Work Order ID 64203

Item Name: Vertical Tunnel, Aft Center

DESIGN	SC	DART AEROSPACE LTD HAWKESBURY, ONTARIO, CANADA	
DRAWN	SC		
CHECKED		DRAWING NO.	REV. A
MFG. APPR.		D3829	SHEET 3 OF 3
APPROVED		TITLE	SCALE
DE APPR.		VERTICAL TUNNEL (BELL 206 L/L1)	NTS
DATE	10.10.21	COPYRIGHT © 2010 BY DART AEROSPACE LTD THIS DOCUMENT IS PRIVATE AND CONFIDENTIAL AND IS SUPPLIED ON THE EXPRESS CONDITION THAT IT IS NOT TO BE USED FOR ANY PURPOSE OR COPIED OR COMMUNICATED TO ANY OTHER PERSON WITHOUT WRITTEN PERMISSION FROM DART AEROSPACE LTD.

From: David Shepherd [dshepherd@dartaero.com]
Sent: Tuesday, January 04, 2011 4:46 PM
To: 'Marc Bellavance'
Cc: 'Leger, Daryl'; 'Downing, Eric'; 'Murdoch, Jason'
Subject: RE: D3829-3 Vertical Tunnel Pannel

D3829-3 VERTICAL TUNNEL, AFT CENTER

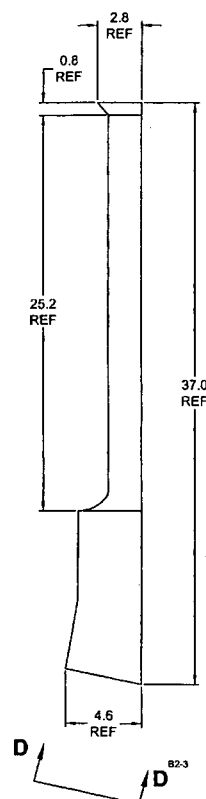
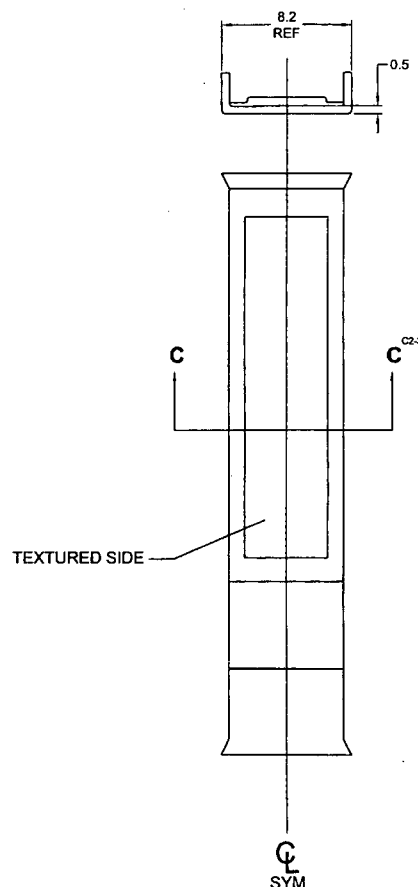
NCR: 64203		WORK ORDER NON-CONFORMANCE (NCR)						
DATE	STEP	Description of NC Section A	Corrective Action Section B			Verification Section C	Approval Chief Eng	Approval QC Inspector
			Initial Chief Eng	Action Description Chief Eng	Sign & Date			
10/12/03	# 120	Found crack in both corner in all parts (qty x2) on upper end Re: Tooling / process	<u>/</u> RESUME	See below ↓			<u>/</u> RESUME	<u>S</u> 10/12/03
11/01/06	# 120	<u>SAME</u>	<u>/</u> 11/01/06 081042	TRIM PER OPTION #3 OF ATTACHED EMAIL	<u>Wh.</u> 11/01/06	<u>S</u> 11/01/06	<u>/</u> 11/01/06 081042	<u>S</u> 11/01/06

Upon thermoforming the part, webs that must be removed are created in the corners where you see gaps – highlighted in red – in attached not-that-clear picture.

DC is not happy with those and Daryl insists there are no other way of doing this but modify the mold which will take considerable amount of time and will scrap a few sheets of material during the process.

Note that installers will trim this considerably, more or less the same as what Russ did when installing the panel here for trial install.

Options are:

- Scrap parts and rework mold – a costly solution;
- Stop drill the gap;
- Trim portion of panel same as what was done during DART's trial install to eliminate gap.

As discussed, I recommend option 3.
